February 16, 2023

RE: Comments on Draft Environmental Impact Statement for the Delta Conveyance Project

Figure 30A-2. Projected Absolute Changes in Precipitation, Evapotranspiration, and Runoff for Major Watersheds in the Sacramento and San Joaquin River Basins for 2040 CT, Compared to Historical Reference Period (1995)

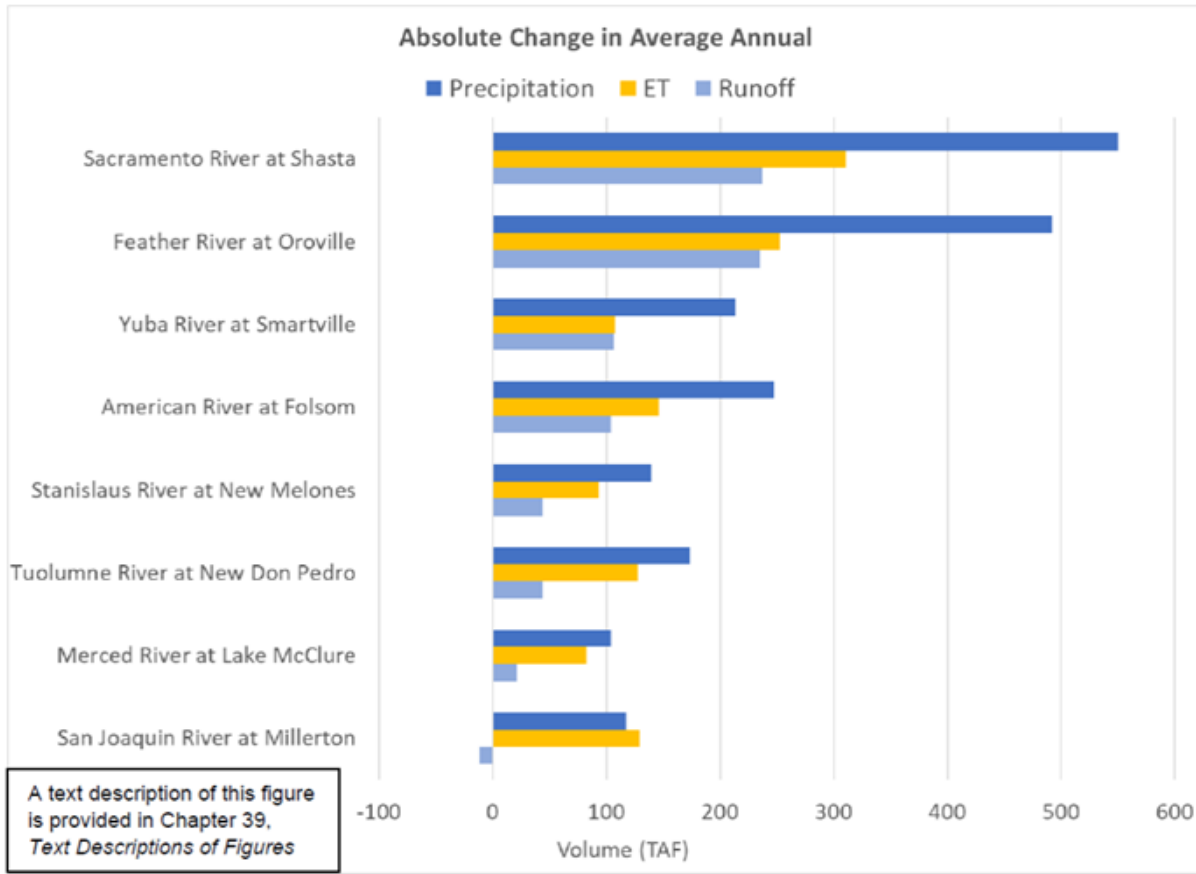
Second, the DEIR fails to provide a reasoned explanation why the No Action Alternative and other modeling of climate change effects use the Central Tendency of the climate models, which predicts precipitation and annual runoff will **increase** compared to today. *See* DEIR at 30-20 (concluding that by 2040 climate change will increase precipitation compared to 1981-2010

conditions: “all major watersheds are projected to be wetter, with average precipitation increases from 2.7% to 4.8%.”); *id.*, Appendix 30A, at Figure 30A-2. DWR’s modelling of the Central Tendency shows increased runoff in the state’s rivers, as the graphic below shows, which means there is more water than today to be captured and exported by the tunnel – not less water than today:

Figure 30A-3. Projected Changes in Precipitation, ET, and Runoff for Major Watersheds in the Sacramento and San Joaquin River Basins for 2040 Median, Compared to Historical Reference Period (1995)

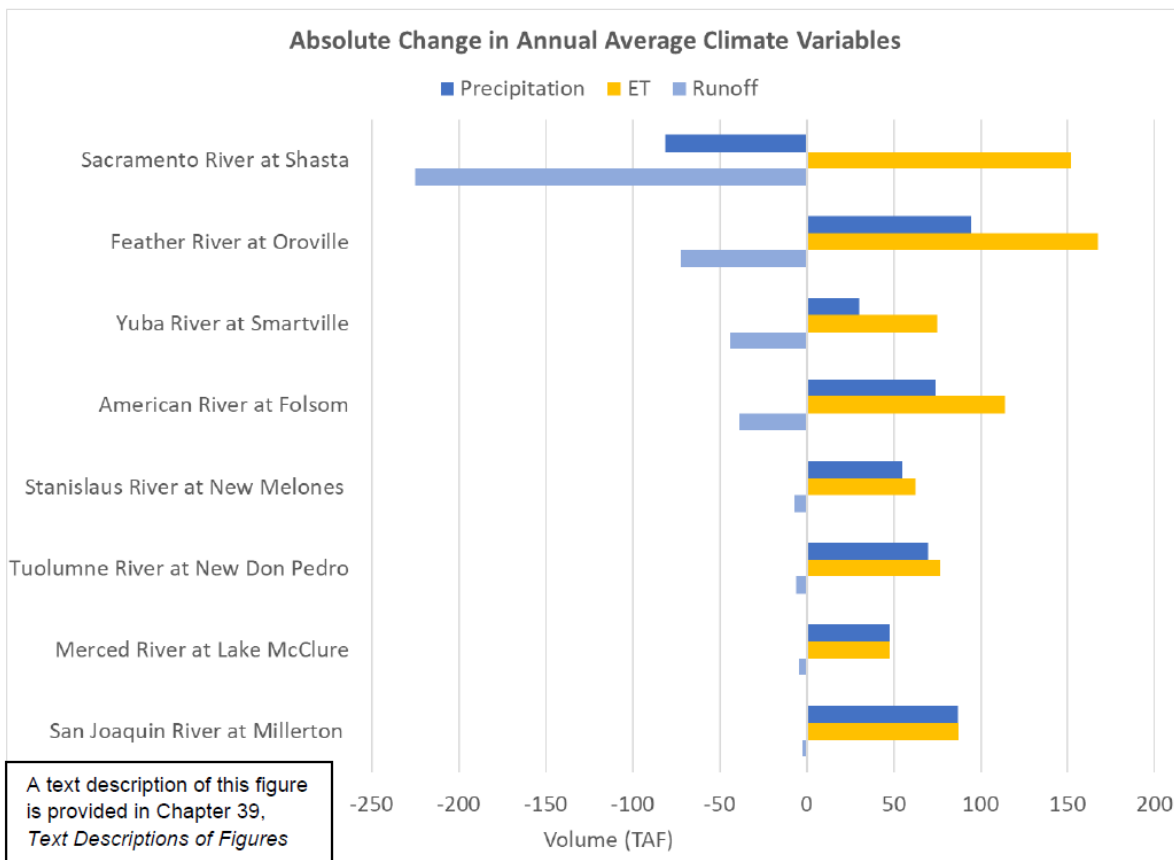
In contrast to the Central Tendency, the DEIR also presents results of the Median climate models, which predicts decreased runoff compared to the historical record:

However, the DEIR does not use the 2040 Median climate change modeling, despite the fact that the median is a better reflection of the “typical” year and is not overly influenced by extremely wet years, as the “mean” (or central tendency) metric is. This median prediction appears more consistent with hydrology over the past two decades. As the DEIR admits, “[i]n the context of climate change, projections of future precipitation are even more uncertain than projections for

temperature. Uncertainty regarding precipitation projections is greatest in the northern part of the state, and a stronger tendency toward drying is indicated in the southern part of the state.” DEIR at 5-4. Given this uncertainty, it is irresponsible for the DEIR to assume increased precipitation as a result of climate change (Central Tendency) without equally considering reduced precipitation and runoff as a result of climate change (2040 Median).

Figure 1. Spring-run exposure of a potential spring pulse protection period

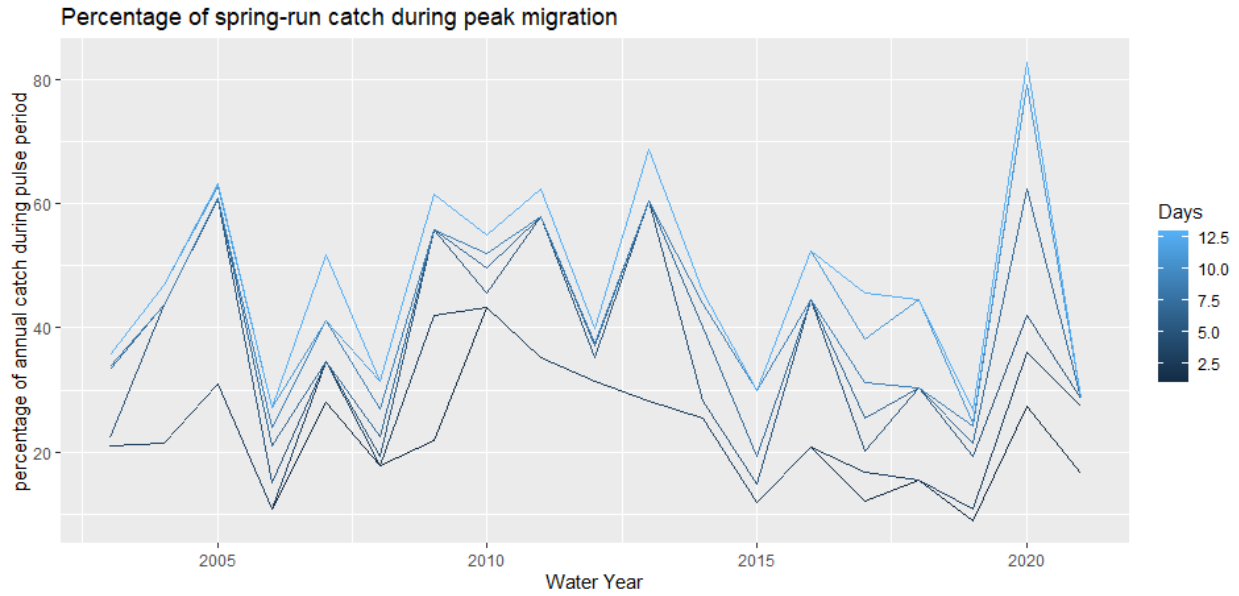
The addition of a spring pulse protection period could provide protection for a large portion of spring- and fall-run Chinook salmon by reducing their exposure to near-field effects of the NDD. Figure 1 illustrates the percentage of the yearly juvenile spring-run cohort (again, using trawl catch as a proxy) that could be protected by a spring pulse of varying length. Each line represents a pulse protection period of a different length; potential pulse protection periods of 1, 3, 5, 7, 9, 11, and 13 days are shown. For comparison, pulse protection periods in DWR example data years occurred for durations of five to 13 days. Plotted pulse protection periods are centered around the day with maximum spring-run Chinook salmon catch for that water year in the Sherwood Harbor Trawl.

There is overlap in some of the lines of differing pulse protection period lengths, where changes in the length of the pulse protection period does not change the catch. This could be due to no additional catch during those additional days or no trawl samples collected in those additional days since the Sherwood Harbor trawl does not sample daily (sampling is generally three times per week).
